Subject: Request for Additional Information
Keene Road Disposal/Buttrey Development
Application Nos. SC48-0165969-008 & SO48-0165969-009

Orange County - SW
Keene Road Disposal/Buttrey Development,
Class III Landfill Expansion - Construct & Operate
Modification of Permit Nos. SC48-0165969-001 & SO48-0165969-002
Permit Application Nos. SC48-0165969-008 & SO48-0165969-009

TO: George Cheryan
THROUGH: Jim Bradner, P.E. 
FROM: Deborah Helle, P.G. 
DATE: August 25, 2004
SUBJECT: Keene Road Buttrey 4 RAI Response Review

Subject: Request for Additional Information
Keene Road Disposal/Buttrey Development
Application Nos. SC48-0165969-008 & SO48-0165969-009

EXHIBIT G

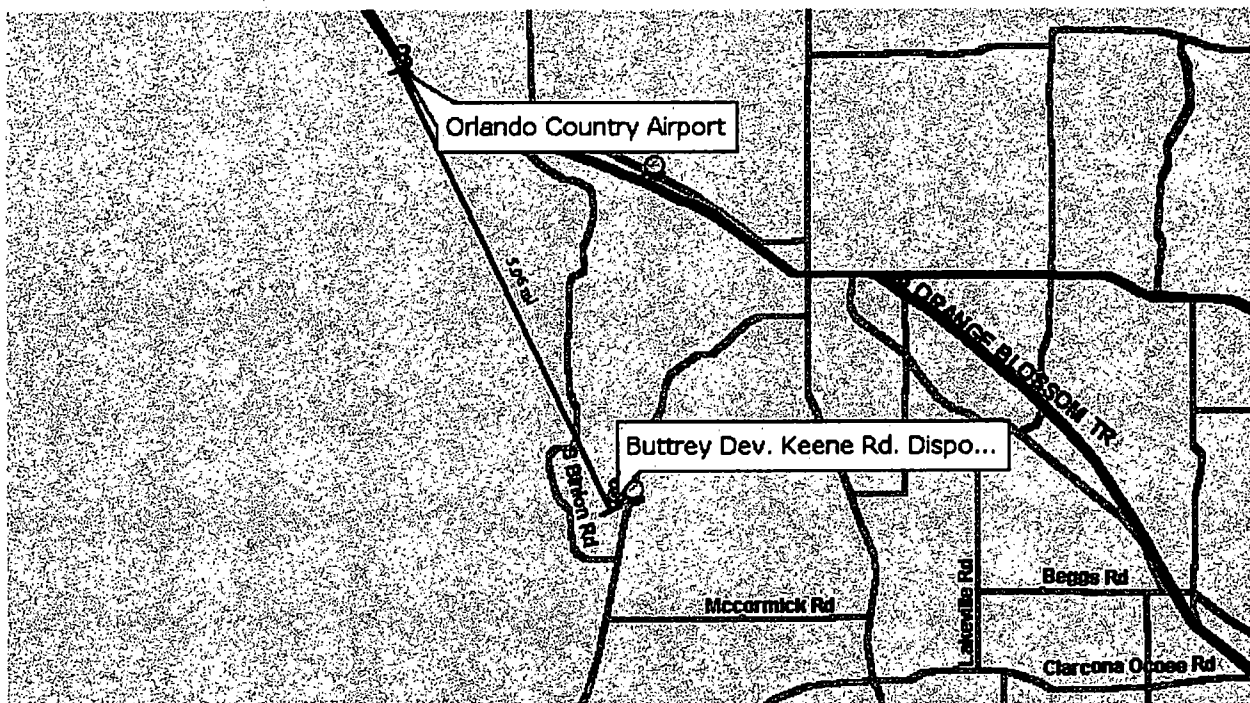
7. Page 48, Section 1.20.2 of the report, references a map which has not been received. Submit the map or provide the revised page with the appropriate reference.

Response: Attached as Exhibit G is the map referenced on page 48, Section 1.20.2.

EXHIBIT K

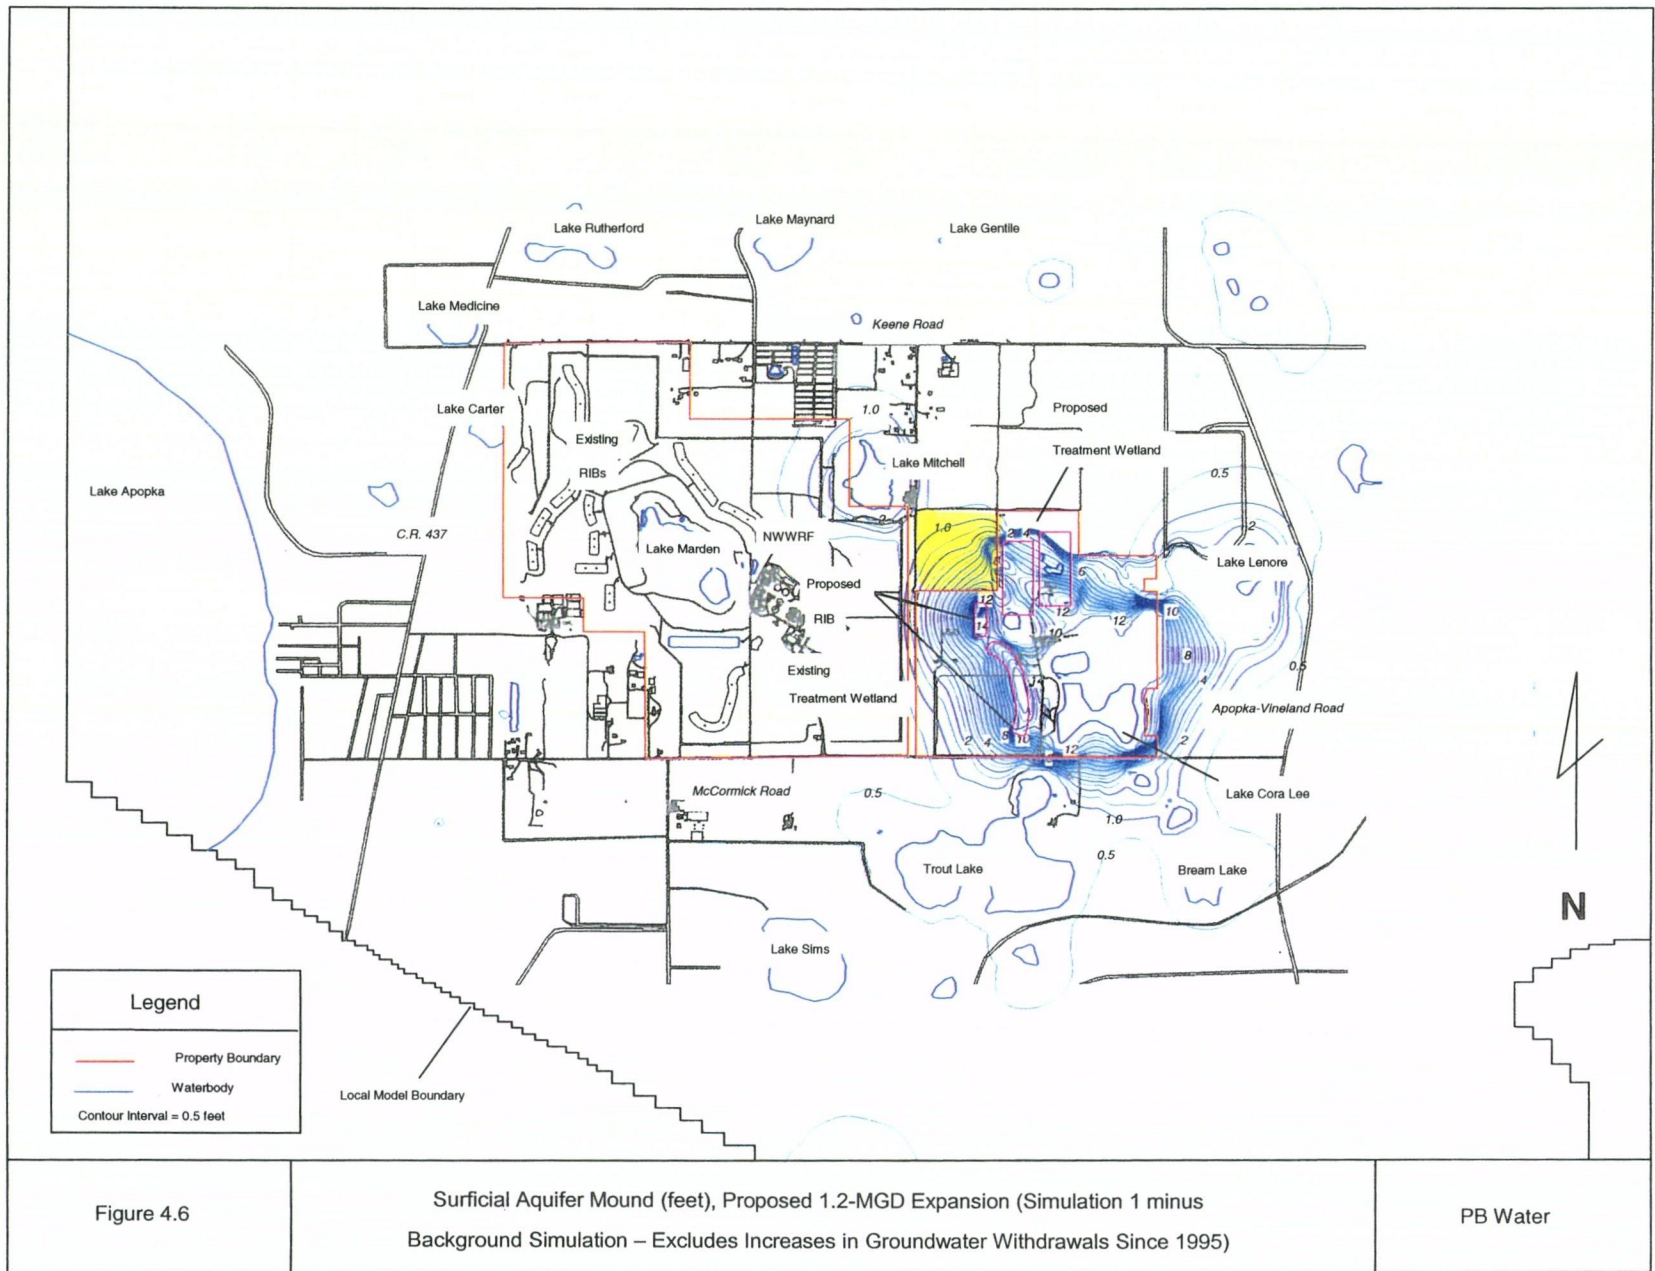
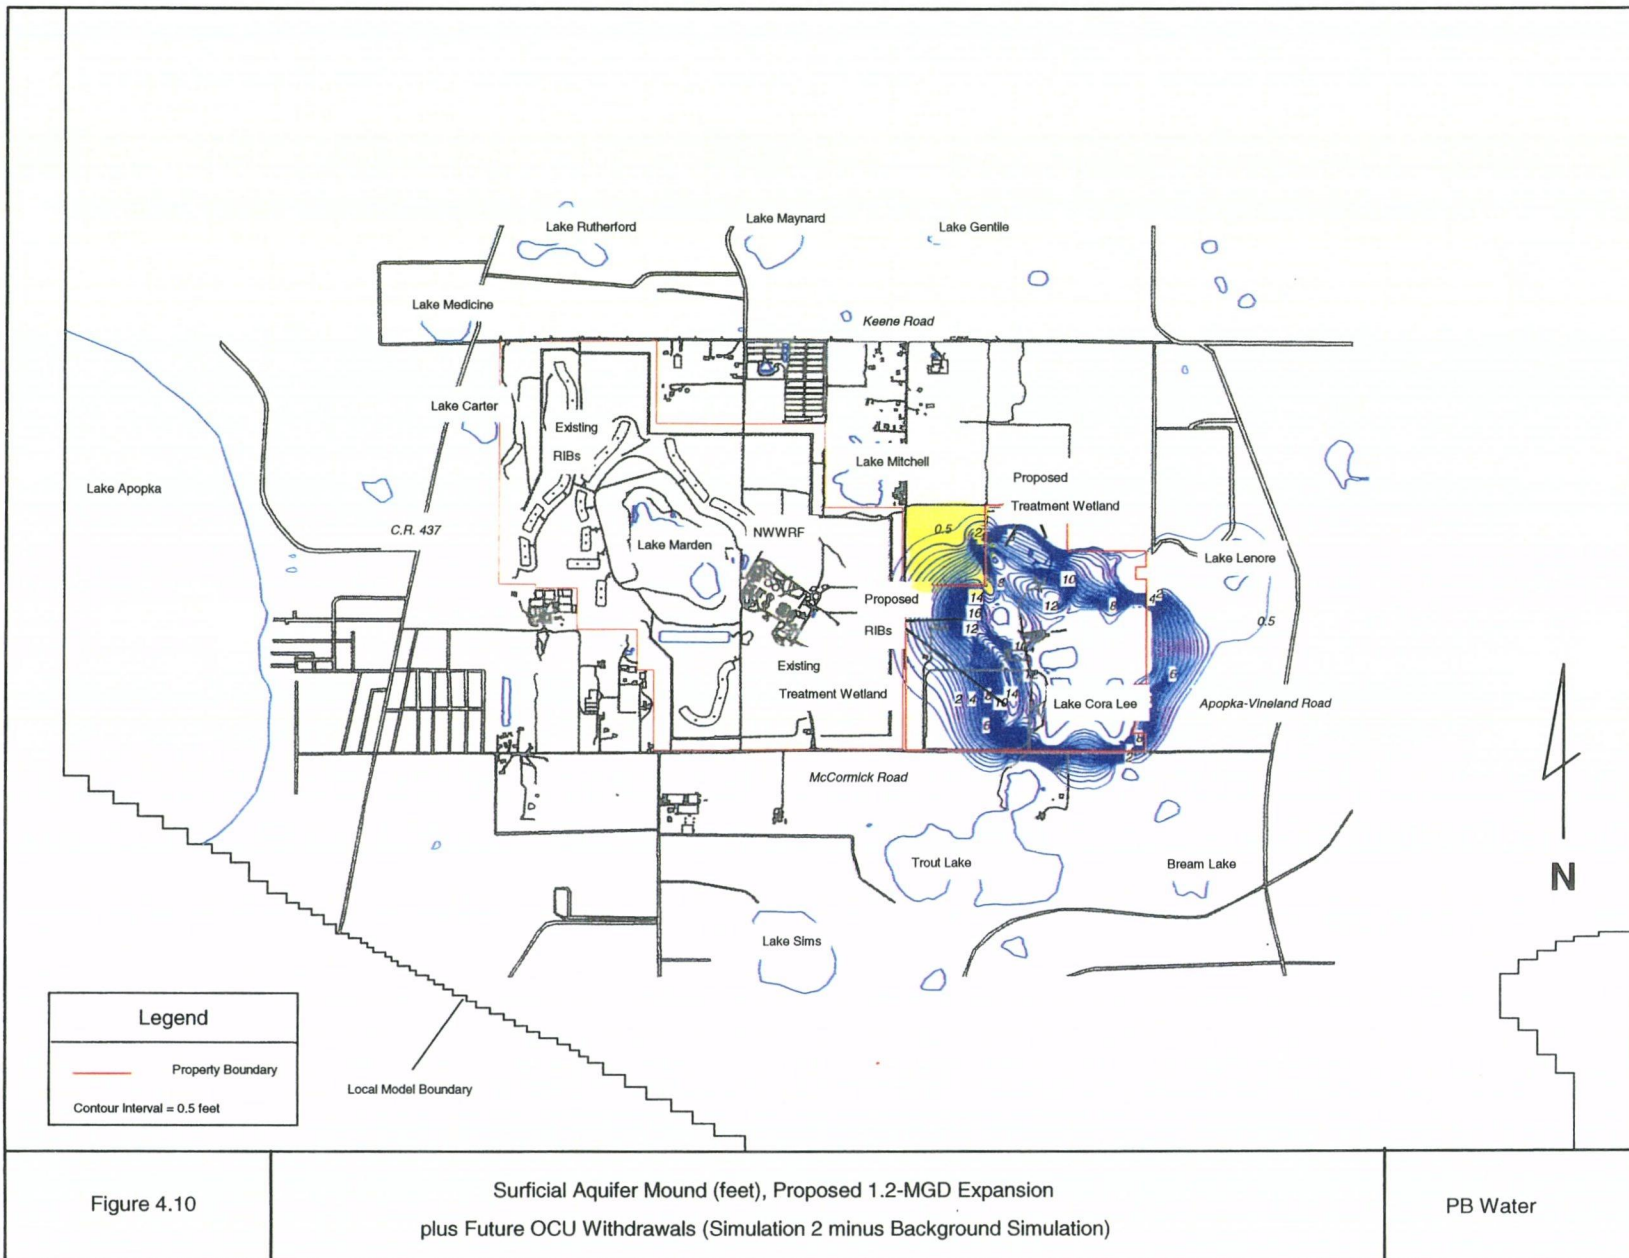
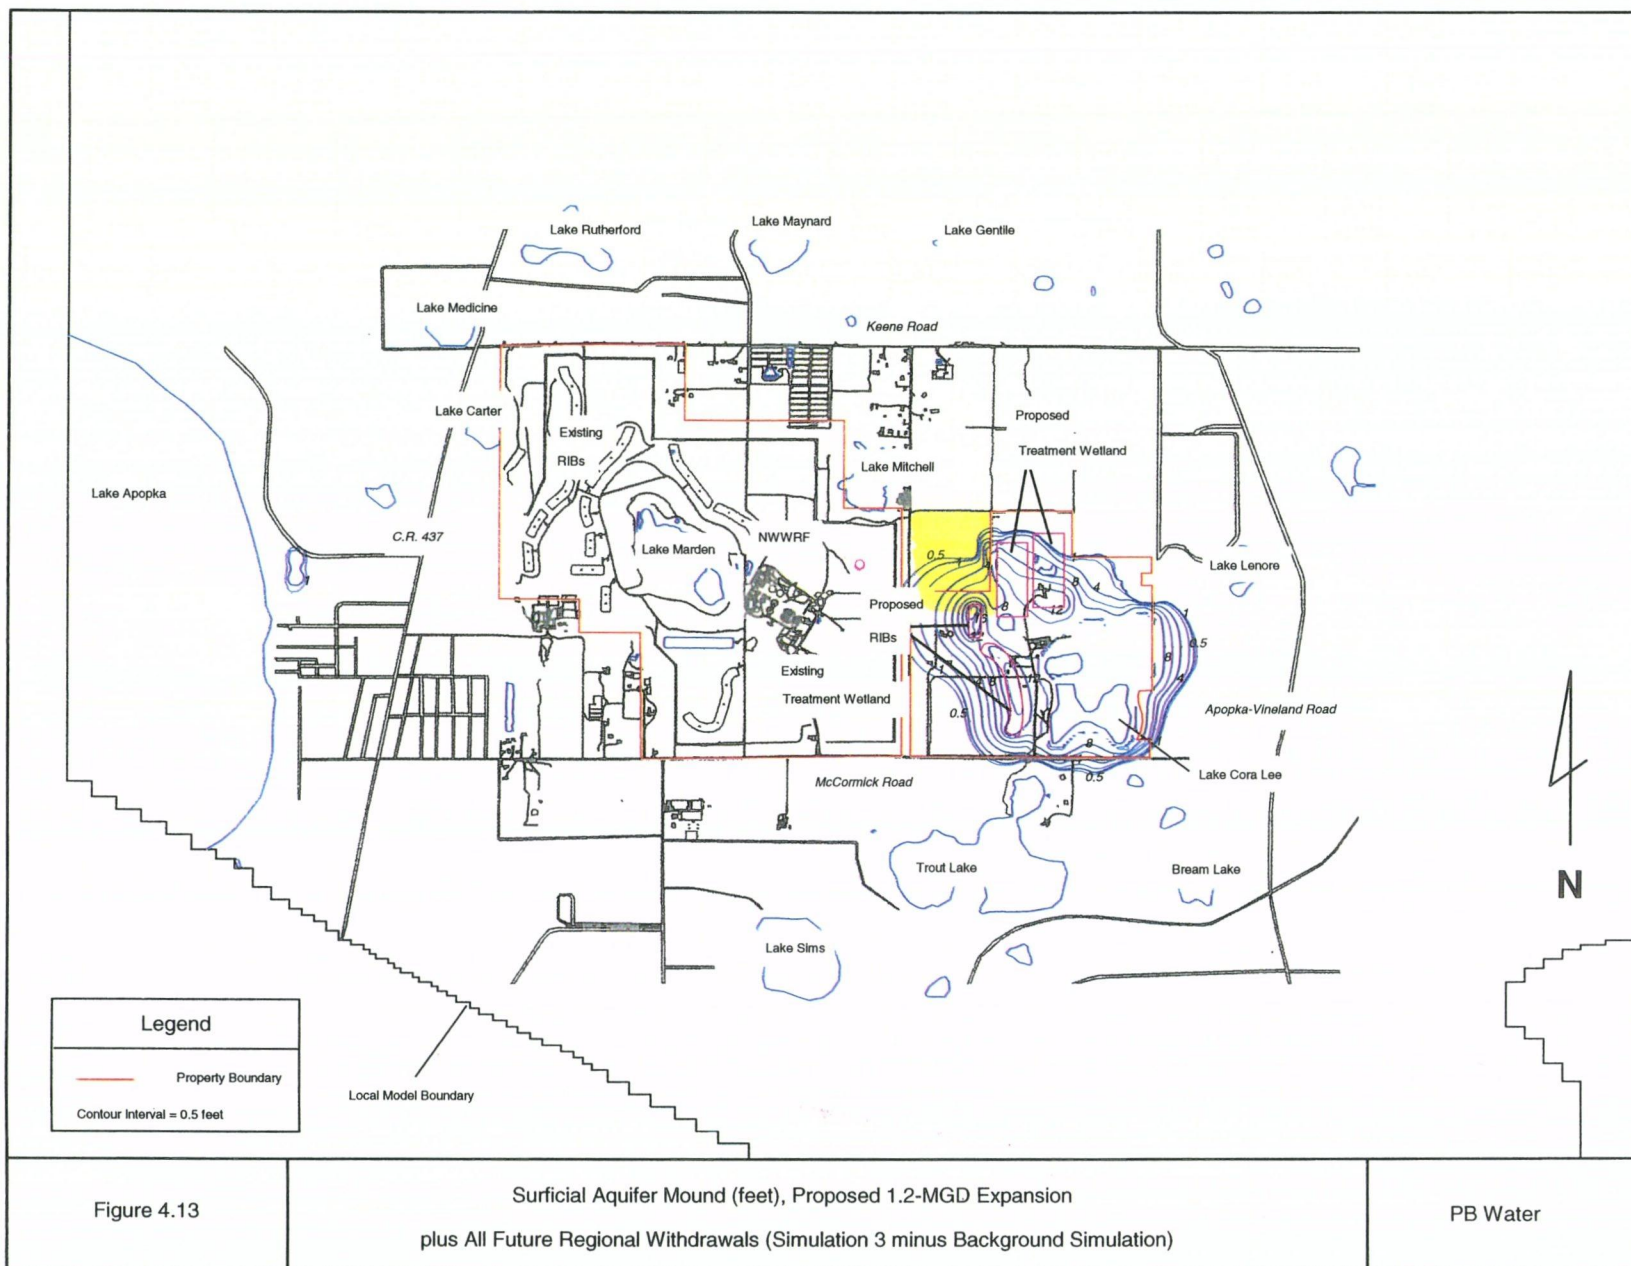
12. The Water Table Estimates & Proposed Base Grade Elevations report does not incorporate any anticipated mounding impact resulting from the Lake Cora Lee wetland treatment system to the east of BD4, and the proposed rapid infiltration basins (RIBs) south of BD4. The boundaries of these proposed projects are within 0-100 feet of BD4 and must be taken into account as part of the permit application review process. Submit a map showing the projected surficial ground water aquifer contours with the proposed Lake Cora Lee and RIBs impacts. The map should be the same scale as Figure 4, Base Grade Elevations BD4 Parcel, so that they may be compared.

Attached as Exhibit K are three Figures (Figures 4.6, 4.10, & 4.13) all submitted as part of the above referenced PB Water Report. These figures depict the expected surficial aquifer mound as a result of the Lake Cora Lee & RIB expansion project under three different scenarios. The three Figures compare several different operating conditions for the Orange County Utilities (OCU) NWWRF, and their nearby Northwest Service Area (NWSA) municipal well field. The BD4 site has been highlighted in yellow for reference.

Figure 4.6 (Simulation 1) depicts the NWWRF operating at fully permitted capacity and the nearby NWSA well field operating at its 1995 withdrawals volumes.

Figure 4.10 (Simulation 2) depicts the NWWRF operating at fully permitted capacity and the nearby NWSA well field operating at its permitted withdrawal volumes.

Figure 4.13 (Simulation 3) depicts the NWWRF operating at full capacity and the nearby NWSA well field operating at future projected 2010 withdrawal volumes.
